**COLORADO DIVISION OF RECLAMATION, MINING AND SAFETY**  
**MINERALS PROGRAM INSPECTION REPORT**  
**PHONE: (303) 866-3567**

<b>MINE NAME:</b> Gunkel Pit No 31	<b>MINE/PROSPECTING ID#:</b> M-1993-088	<b>MINERAL:</b> Gravel	<b>COUNTY:</b> Baca
<b>INSPECTION TYPE:</b> Monitoring	<b>INSPECTOR(S):</b> Amy Eschberger	<b>INSP. DATE:</b> November 20, 2014	<b>INSP. TIME:</b> 11:00
<b>OPERATOR:</b> Baca County	<b>OPERATOR REPRESENTATIVE:</b> Jason Freiburger and Race Chenoweth	<b>TYPE OF OPERATION:</b> 112c - Construction Regular Operation

# M1993-088 / Gunkel Pit No. 31 / Baca County

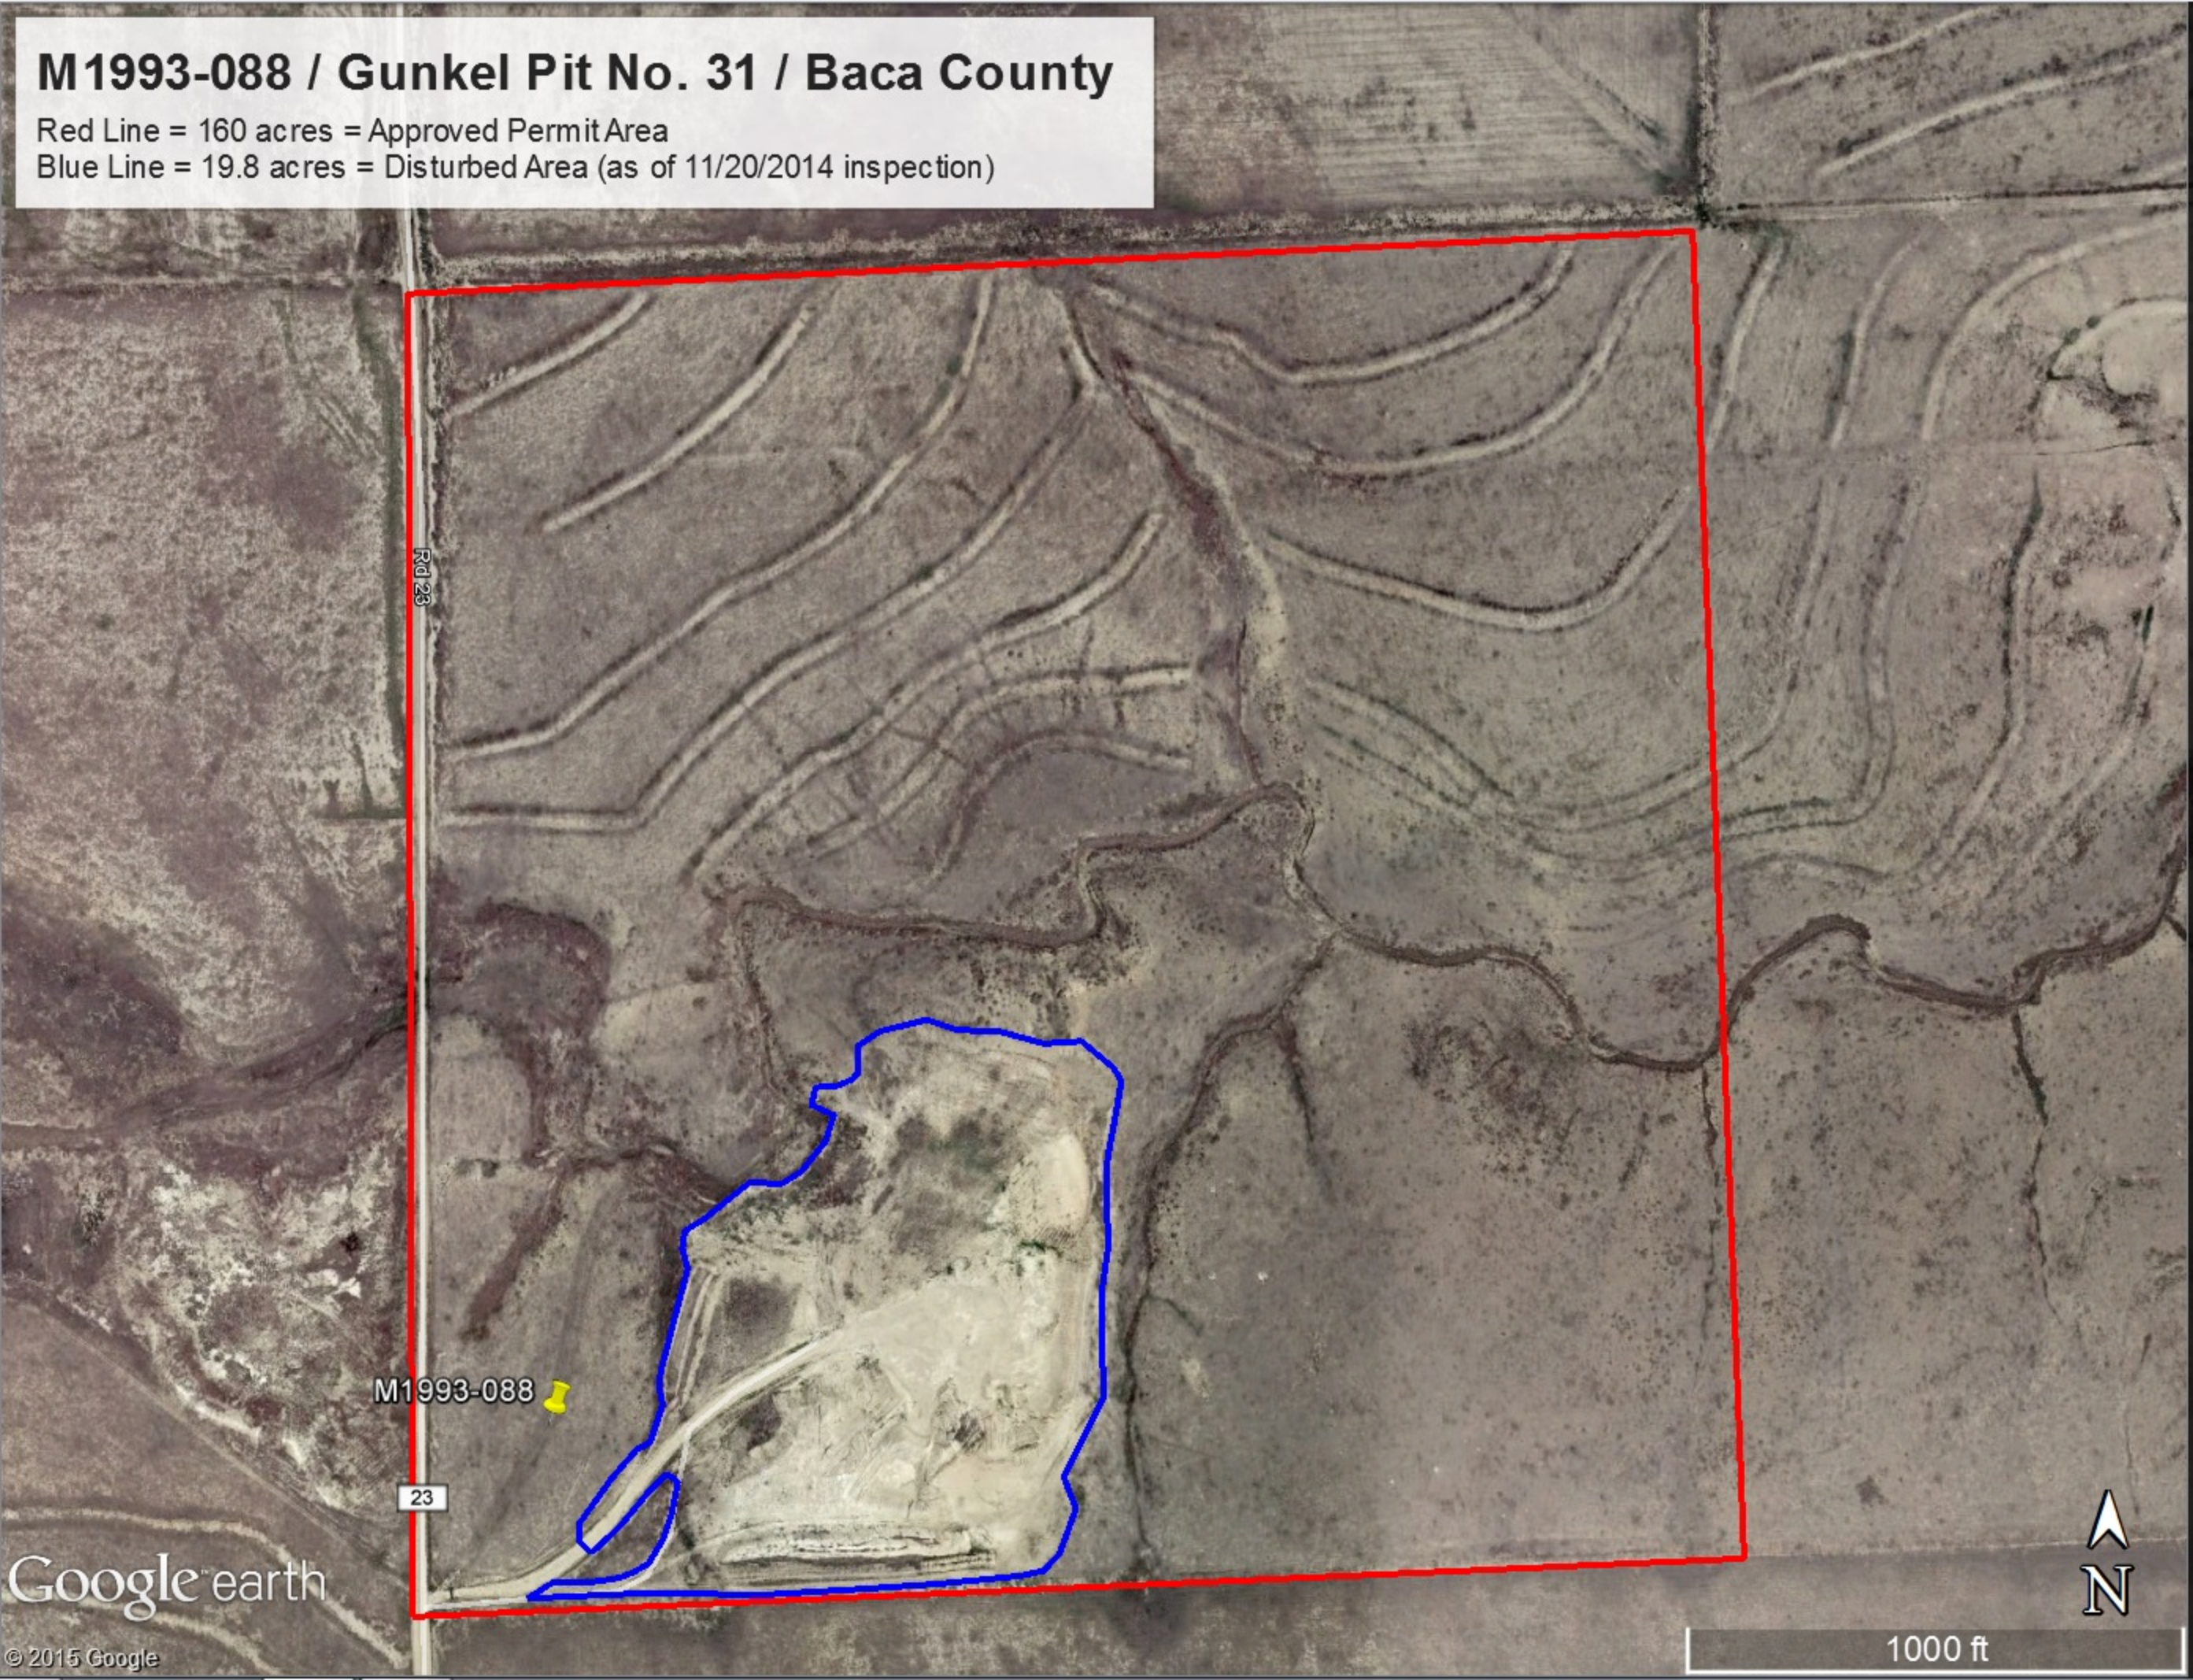
The Division estimates that approximately 19.8 acres have been disturbed by this operation (see enclosed Google Earth image of site), which is in compliance with the maximum allowed disturbance. However, before expanding the pit much farther, the operator will need to either fully reclaim a portion of the site (according to the approved reclamation plan) or submit a Technical Revision (see enclosed form) to the approved mining plan to increase the maximum allowed disturbed acreage to more than 20 acres. Current disturbance includes a horseshoe shaped pit with mined walls mainly daylighting to the north and west (**Photo 2**), topsoil and overburden stockpiles stored above the pit along the southern permit boundary (**Photos 3 and 4**), and a separate topsoil stockpile stored immediately north of the main access road (**Photo 5**). The topsoil and overburden stockpiles appeared to be stable with some vegetative cover. The southern (north-facing) highwalls are approximately 25-30 feet in height and have slope gradients of 2H:1V to 3H:1V (**Photos 6 and 7**). The eastern mined slopes were graded to mainly 4H:1V and have some native grasses volunteering across them (**Photo 8**).
